SIB 36 03 22

SERVICE ACTION: REPLACING THE WHEEL ELECTRONICS OF THE  
TIRE PRESSURE MONITOR (TP

E-Series	Model Description	Production Date
G07	X7 Sports Activity Vehicle	August 15-16, 2022

Union nut (1) shown.

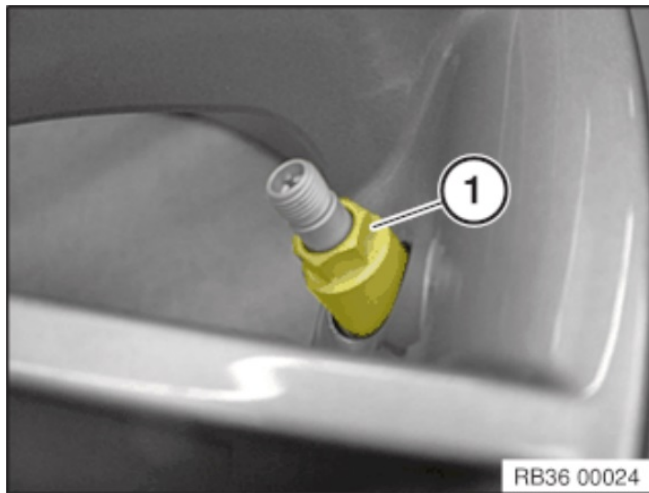
The tire valves were installed without a union nut. A slow leak can develop.

Replace the wheel electronics modules together with the tire valves of the TPM on all 4 wheels.
